ECN/PCN No.: 4263

Product Description: 32.768kHz SMD Crystal	Abracon Part Number / Part Series: ABS06	<input type="checkbox"/> Documentation only <input checked="" type="checkbox"/> ECN <input type="checkbox"/> EOL	<input checked="" type="checkbox"/> Series <input type="checkbox"/> Part Number
Affected Revision: K	New Revision: L	Application:	<input type="checkbox"/> Safety <input checked="" type="checkbox"/> Non-Safety

Mechanical Dimensions:

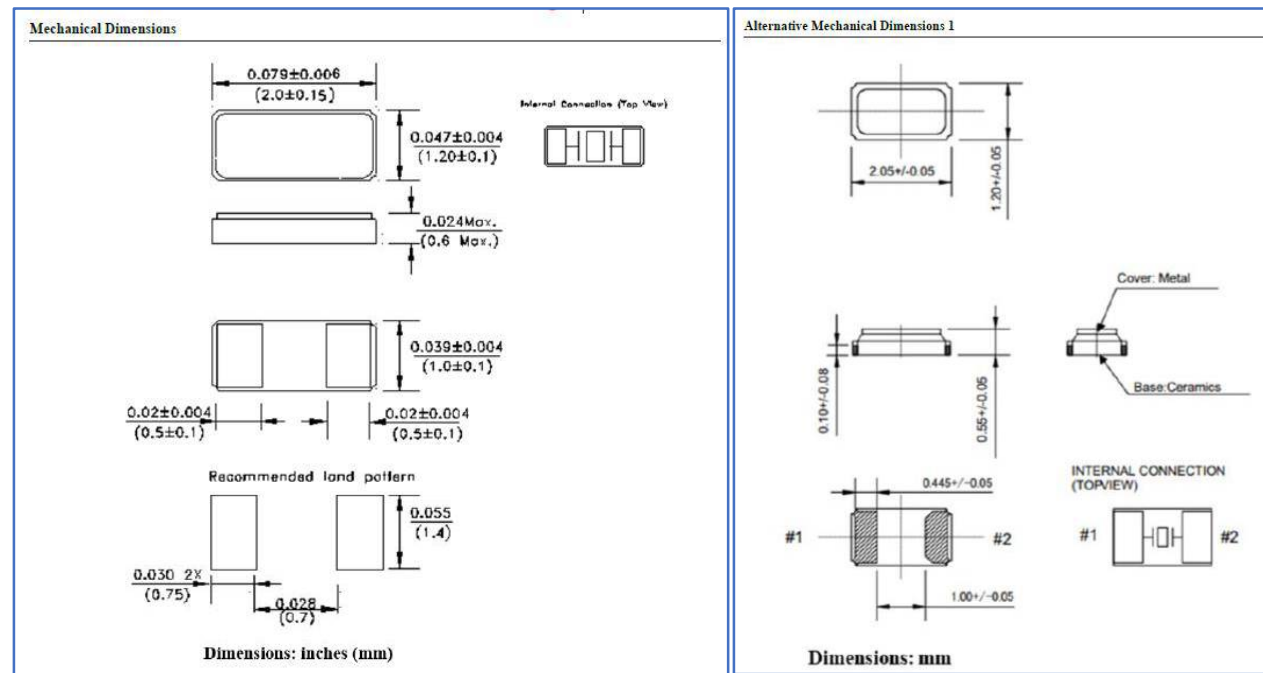
Prior to Change:

Shunt capacitance (C0), typical value= 0.9~1.2pF

Mechanical Dimensions:

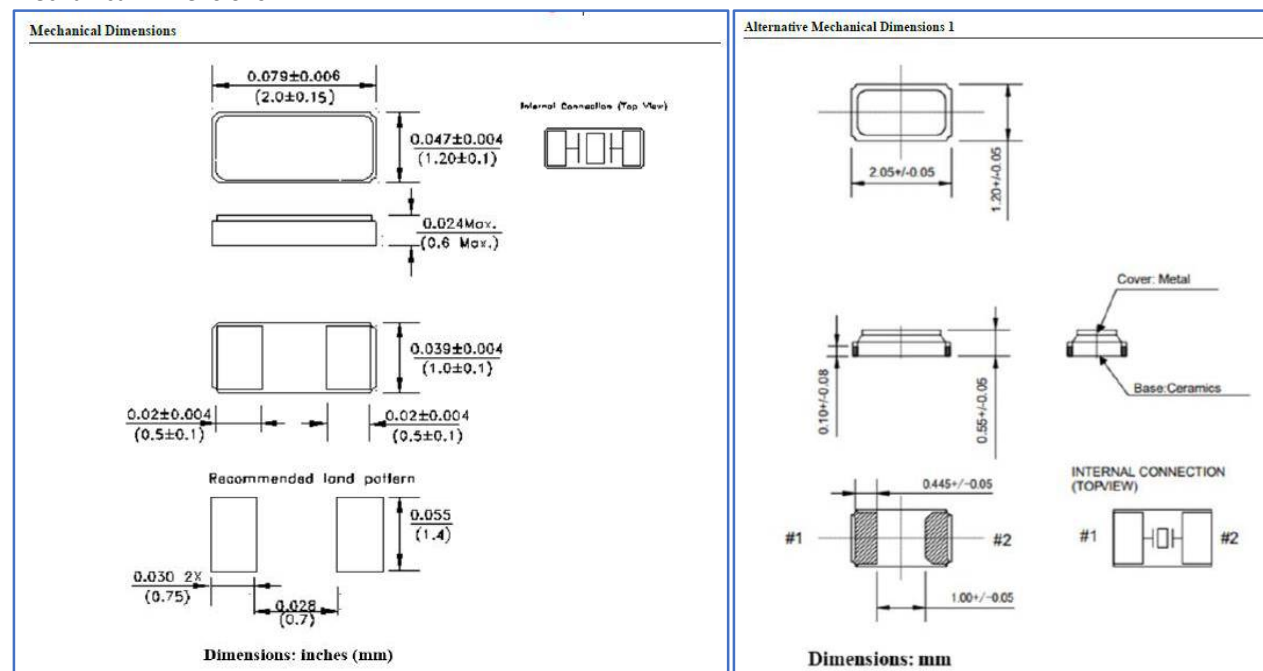
After Change:

Shunt capacitance (C0), typical value= 0.9~1.4pF

Abrakon introduced additional manufacturing sources to ensure product availability and to be in a better position to meet long term customer demand. Updated electrical specifications and added an alternative bottom packaging structure to reflect the product produced by all manufacturing sources.
